*RCSI Bulletin 128  
Outer Loop Alternates*

Metropolitan Ecology  
Bulletin #128

Outer Loop Alternates<sup>\*</sup>

# CRITTENDEN ROAD ALTERNATE

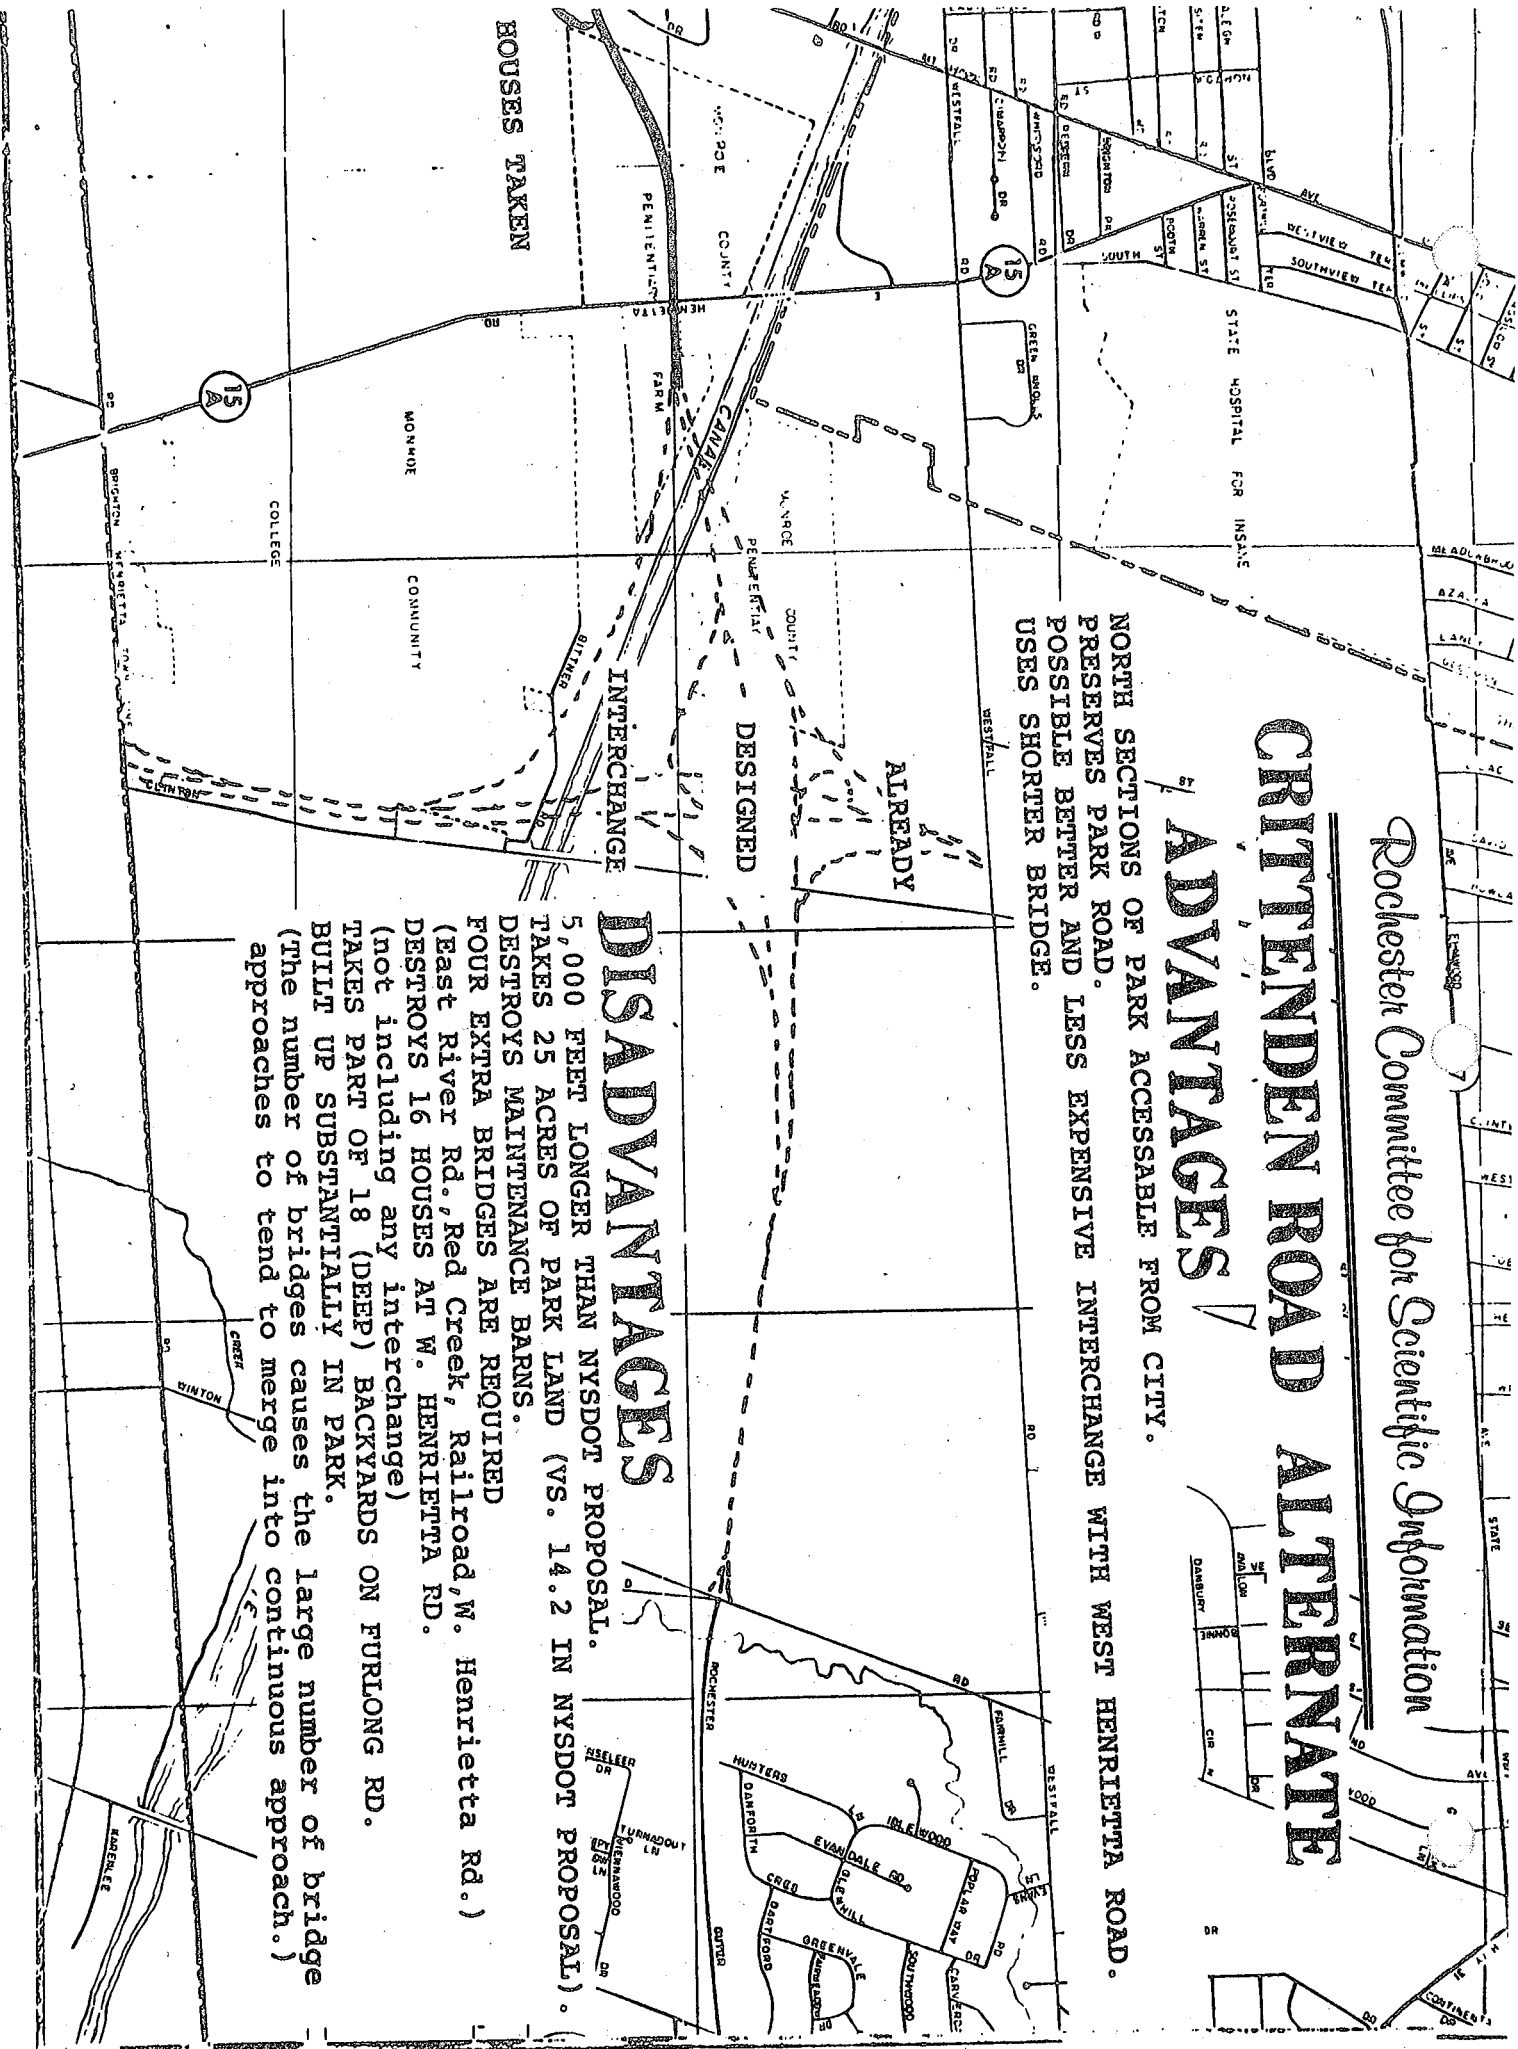
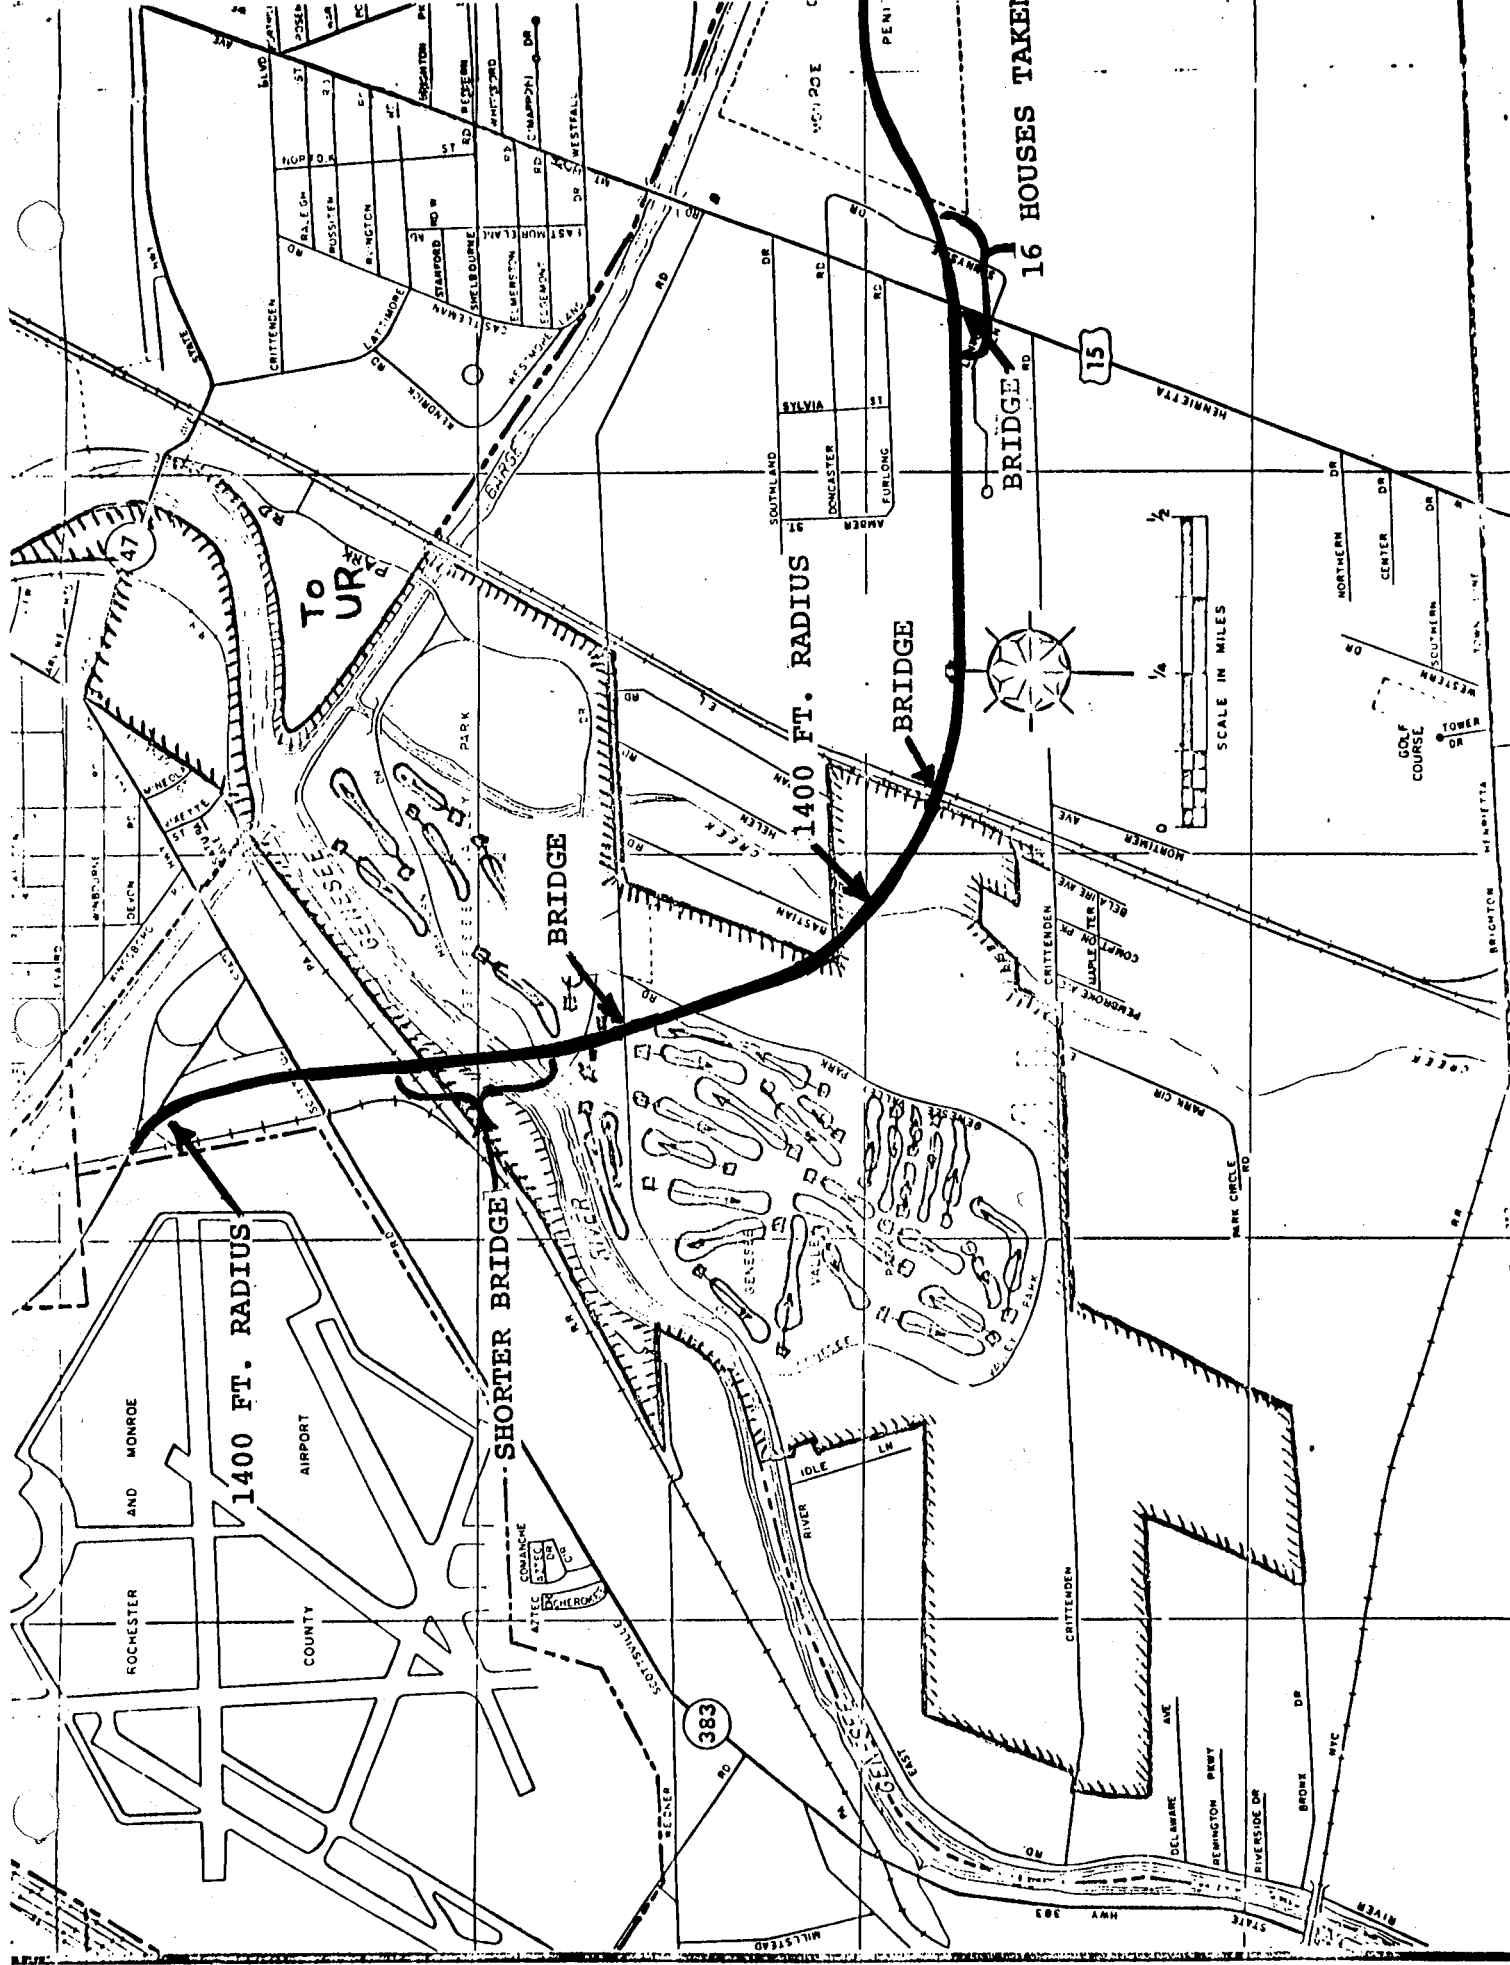
NORTH SECTIONS OF PARK ACCESSABLE FROM CITY.  
PRESERVES PARK ROAD.  
POSSIBLE BETTER AND LESS EXPENSIVE INTERCHANGE WITH WEST HENRIETTA ROAD.  
USES SHORTER BRIDGE.

5,000 FEET LONGER THAN NYS DOT PROPOSAL.  
TAKES 25 ACRES OF PARK LAND (VS. 14.2 IN NYS DOT PROPOSAL).  
DESTROYS MAINTENANCE BARNS.  
FOUR EXTRA BRIDGES ARE REQUIRED (East River Rd., Red Creek, Railroad, W. Henrietta Rd.)  
DESTROYS 16 HOUSES AT W. HENRIETTA RD.  
(not including any interchange)  
TAKES PART OF 18 (DEEP) BACKYARDS ON FURLONG RD.  
BUILT UP SUBSTANTIALLY IN PARK.  
(The number of bridges causes the large number of bridge approaches to tend to merge into continuous approach.)

# EAST RIVER ROAD ALTERNATE

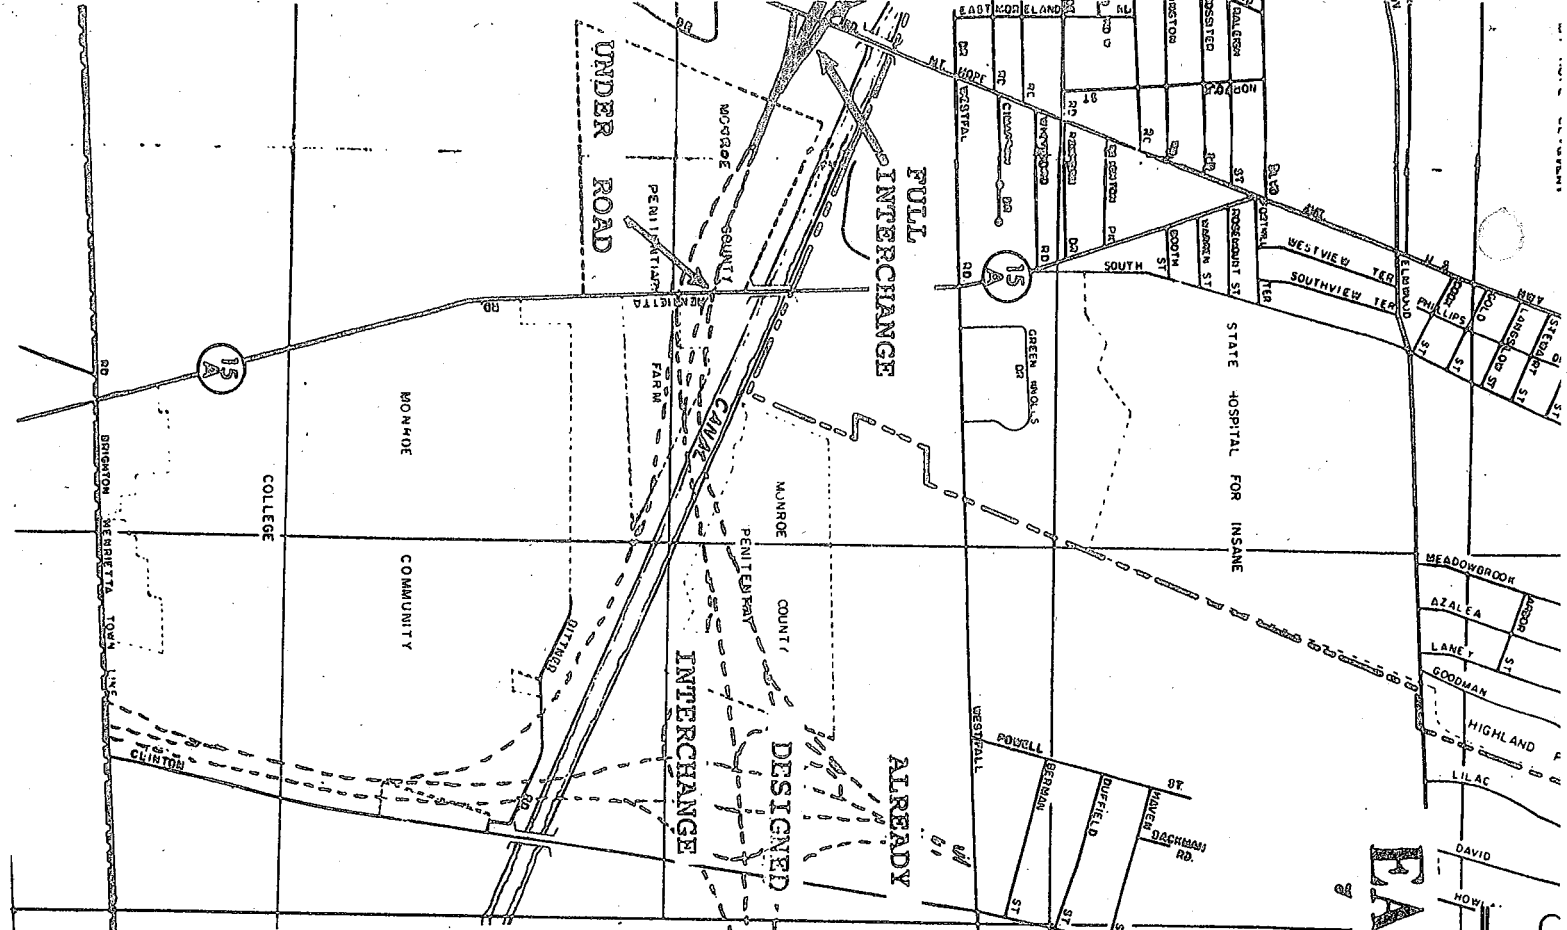
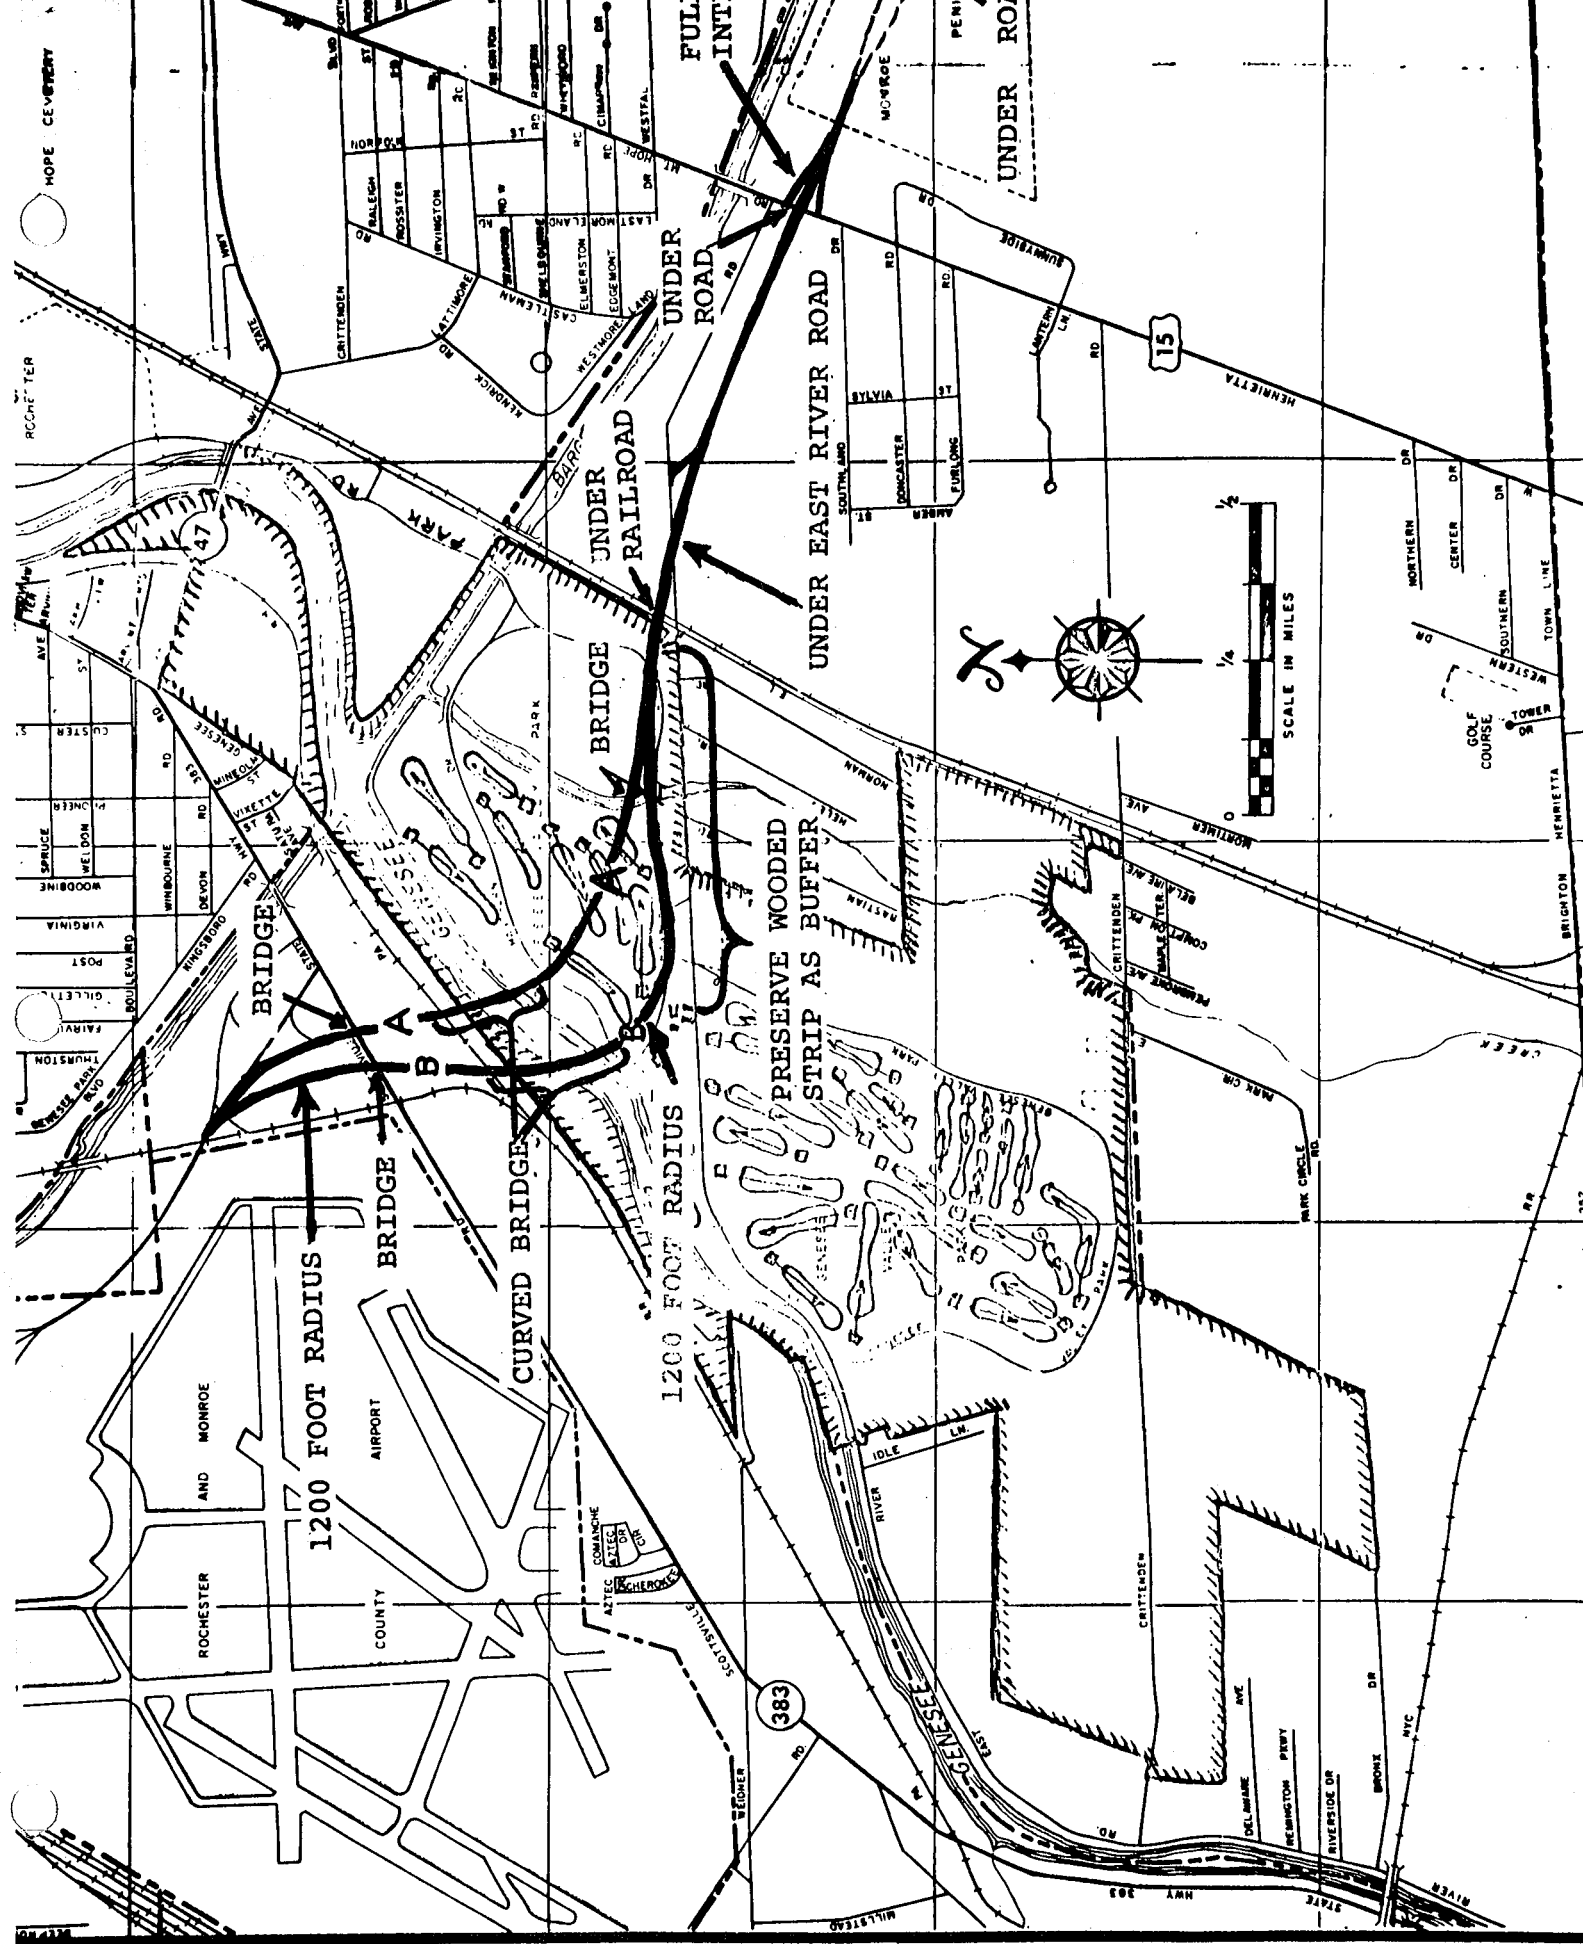
NORTH SECTIONS OF PARK ACCESSIBLE FROM CITY.

PRESERVES PARK ROAD.

SHORTER BRIDGE OVER THE GENESEE RIVER.

Route A:  
1,000 FEET LONGER THAN NYS DOT PROPOSAL.

TAKES 19.9 ACRES OF PARK (VS 14.2 in NYS DOT PROPOSAL)

CUTS 4 HOLES OF GOLF COURSE but preserves wooded

Route B:  
2,000 FEET LONGER THAN NYS DOT PROPOSAL.

TAKES 24 ACRES OF PARK.

ROUTE B HAS SHARPER 1200 FOOT RADIUS CURVES.

CURVED BRIDGE is about 10% more expensive
